Explanation of Significant Difference for the Monticello Mill Tailings (USDOE) Site Operable Unit III, Surface Water and Ground Water, Monticello, Utah

1.0 Introduction

Figure 2. Treatment System Location

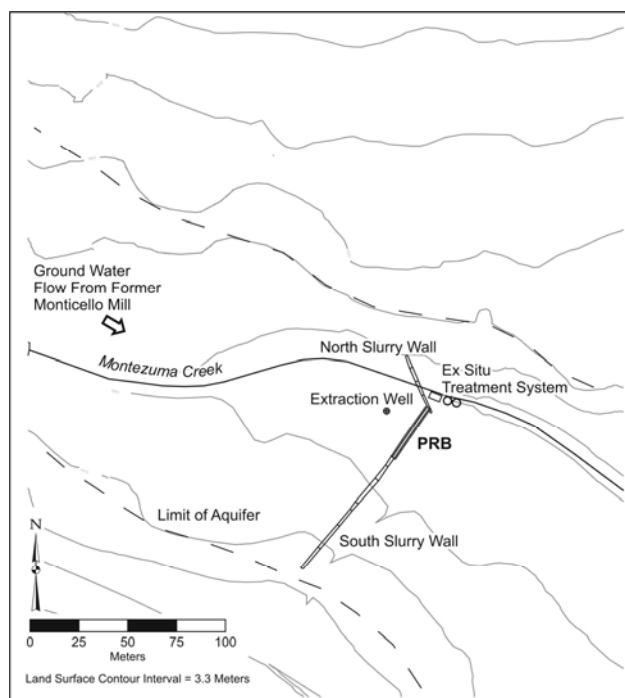
- A pump-and-treat enhancement installed near the PRB as part of a DOE Office of Legacy Management and EPA treatability study will become a component of the contingency remedy for OU III. The contingency remedy evaluation will include operation of the pump-and-treat enhancement upgradient of the existing PRB to evaluate the potential long-term effect of active restoration in reducing contaminant mass and achieving applicable or relevant and appropriate requirements (ARARs). This treatment enhancement may include evaporative treatment and continued treatment with the existing ex situ treatment cells. The treatment will continue until remedial action objectives are met or another remedy is selected. DOE recently met all substantive requirements allowing discharge of treated ground water directly to Montezuma Creek.

- The PRB wall, or a replacement facility that will continue to capture ground water if DOE decides to go forward with decommissioning of the permeable reactive gate, will become part of the remedy. The PRB was designed to allow ground water to flow through and immobilize uranium and other contaminants on zero-valent iron, the reactive medium. However, mineralization within the PRB has significantly reduced its capacity to transmit ground water. To date, the PRB is serving as a barrier to ground water migration and is part of the overall strategy to capture and treat the ground water. DOE will pursue aquifer dewatering using the pump-and-treat enhancement to reduce ground water mounding in preparation for PRB removal.
